BLYTHE ENERGY PROJECT PHASE II

BLYTHE II AMENDMENT SUPPLEMENT #3

Subject: **BLYTHE II AMENDMENT SUPPLEMENT #3**
 BLYTHE II ENERGY PROJECT PHASE II
 DOCKET NO. 02-AFC-1C

Caithness Blythe II, LLC (Caithness) submits this Supplement #3 for the Blythe II Amendment. Supplement #3 provides additional and modified information regarding the Transmission System Engineering portion of the Amendment. In addition this Supplement #3 proposes a modification to Traffic and Transportation condition of certification TRANS-9.

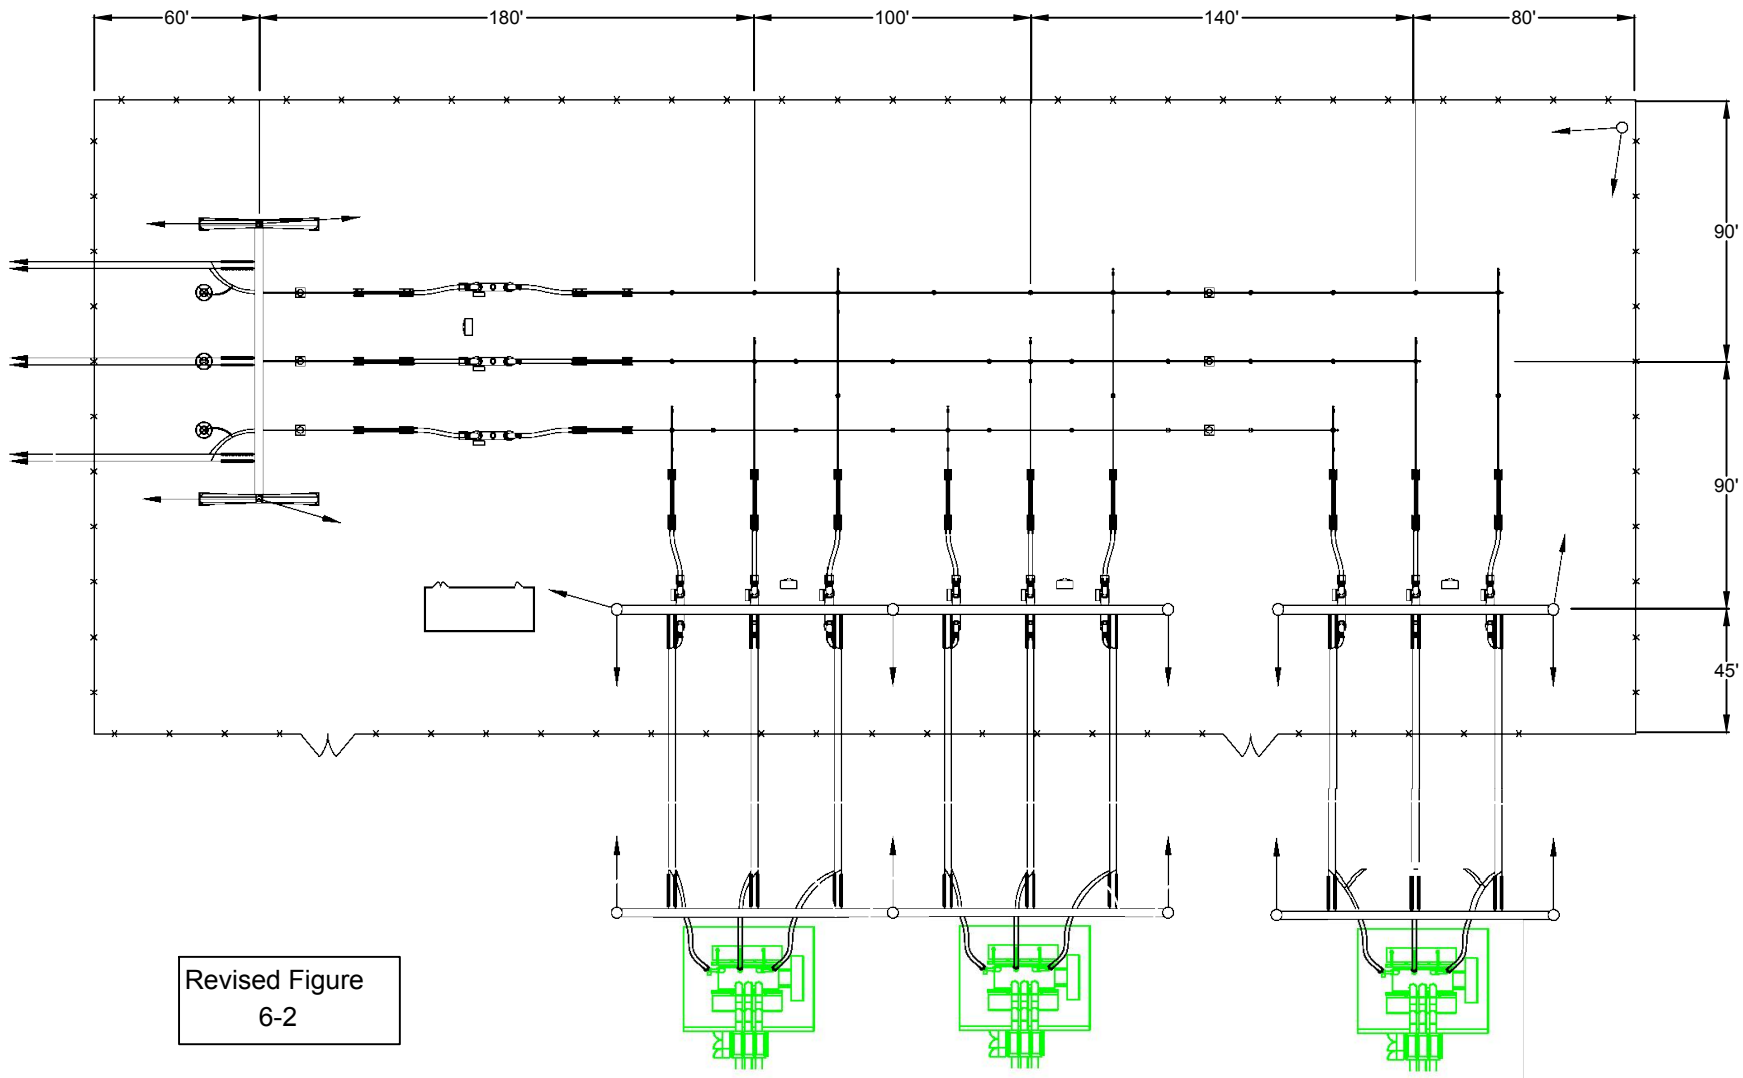
TRANS-9 The Project Owner shall not commence construction of BEP II until the following are accomplished:

1. A remark is placed on the Airport's Automated Surface Observation System (ASOS), or equivalent broadcast, advising pilots to avoid low-altitude direct overflight of the power plant;
2. The VFR traffic pattern to runway 26 is changed from left-hand turns to right-hand turns; and;
3. A runway, other than runway 26, is designated as the primary calm wind runway.

Verification: At least 60 days prior to the start of rough grading or construction, the Project Owner shall submit to the CPM documentation demonstrating the implementation of this condition-, ***including documentation the FAA has approved the VFR traffic pattern to runway 26 from left-hand turns to right-hand turns and a runway, other than runway 26, is designated as the primary calm wind runway.***
